## REMARKS

Claims 36-45 are pending in the application and stand rejected on various grounds as being anticipated and/or obvious in view of prior art references Cameron (WO 00/02803), Sundar (#6,322,312), and Bacchi (#6,275,748) or various combinations thereof.

FIG. 3 (retracted position):  
Vertical surface of moveable wafer engaging pad 34 aligned with fixed rest pads 36

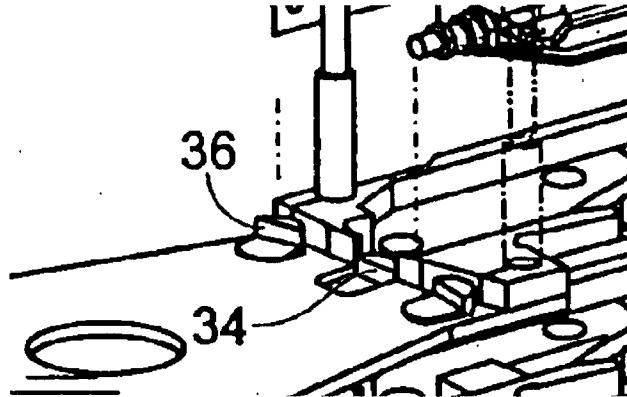
The Examiner has made two objections to the drawings under 37 CFR §1.83(a). In the first objection, the Examiner states that contact pad displacement and optically detecting contact pad displacement (claims 40, 41) must be shown or the feature(s) canceled from the claim(s). In the second objection, the Examiner states that a moving contact pad as specified on page 3 of 13, lines 17-20 should be shown.

The Examiner has required that a moving contact pad as specified on page 3, lines 17-20. As such a feature is already shown in the drawings as filed, no further drawings are deemed necessary. In FIG. 3, for instance, wafer engaging pad 34 is shown with a contacting edge in a retracted position so that it is even with rest pads 36.

FIG. 4 (engaging position - plan view):

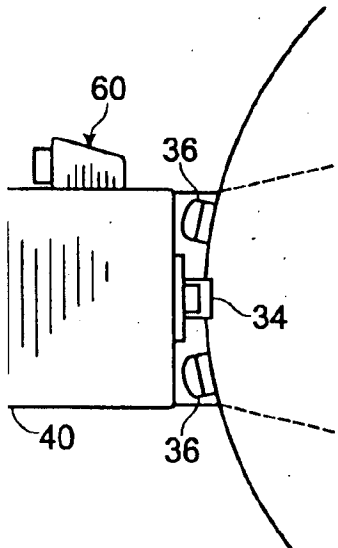
The Examiner has raised a rejection of claim 36 under 35 U.S.C. § 112, first paragraph, on the grounds that Applicants' specification does not make clear how non-pneumatic graspers mechanically grasps a wafer. The Examiner is again directed to FIGs. 4 and 5 (shown above) where wafer W is retained at three contact points between a moveable wafer engaging pad 34 and (fixed) first wafer rest pads 36. Accordingly, Applicants submit that means for mechanically grasping the wafers is explicitly shown in the specification and drawings. Furthermore, those knowledgeable in the art would recognize the term of art as being a clamping engagement of the wafer as shown in the *End Effectors Bible*, submitted as further evidence in the previously filed preliminary amendment.

Once the wafer-to-be-retained is inserted within the device, however, the wafer engaging pad 34 moves to a retaining position as shown in FIG. 4 where the contacting edge is no longer even with rest pads 36.

Wafer engaging pad 34 moved inward for edge contact with wafer W

Applicants reference amendments to claim 36 clarifying the operational step of mechanically grasping as occurring “by contact with opposing peripheral edges” of the wafer. The act of picking up a wafer, as in Cameron, is not equivalent to mechanically grasping edges of the wafer as shown, for example, by FIGs. 4 and 5 of the application.
